Job Title The Farmers Stores, Gatehouse Lane, Goddards Green, Hassocks, BN6 9LE.		Date 014/11/2025
Item Gatehouse Hub 2 – Mid Sussex District Council Flood Risk and Drainage Team Response Note	Job No. E9427	Report No. RE003 A

This response note has been produced by Stephen Wilson Partnership (SWP) in response to the comments from the Flood Risk and Drainage Team at Mid Sussex District Council (MSDC) in regard to the submission of information for clearance of condition 3 of the planning application DM/24/2482. The aim of this note is to summarise the concerns of the Lead Local Flood Authority (LLFA) and explain how the design of the surface water drainage design has been amended based on the comments from the LLFA.

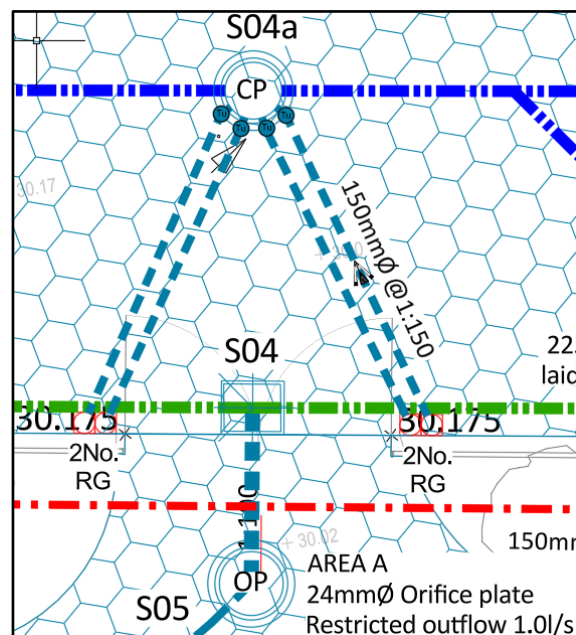
- 1. The depth of water within the permeable paving for catchments B and C exceeds that of the gravel sub-base.*
- 2. Further information should be provided to demonstrate that the proposed SuDS features are adequately sized.*
- 3. It appears that the road gullies discharge downstream of the Area A's orifice plate, and this flow does not appear to be attenuated. Please provide further information.*
- 4. Given the size of the development, we require the level of detail within the drainage calculations to match that within Phase 1 (DM/24/0421).*
- 5. For consistency we would recommend checking that all permeable paving depths are correct throughout the submission.*

1. Agreed, the depth of water in Areas B & C only exceeds the depth of gravel subbase for the 1:100yr +45%CC but does not exceed overall paving depth. It should also be noted that the depth of water does not exceed the depth of sub material for either the 1:30+35%CC storm event or 1:100yr storm event.

Whilst we feel that the current drainage is adequate and meets Mid Sussex guidance effectively, in the interest of addressing this comment and avoiding recurring conversations and delays, the subbase depths will be increased as follows.

Area	Depth of Water (mm)	Depth of Subbase Material (mm)		Increase (mm)
		Current	Proposed	
A	710	750	750	Nil
B	862	750	870	120
C	957	800	960	160

The above table indicates that the maximum water level within the permeable paved areas does not exceed the type 3 gravel subbase material. We trust that addresses this comment satisfactorily.
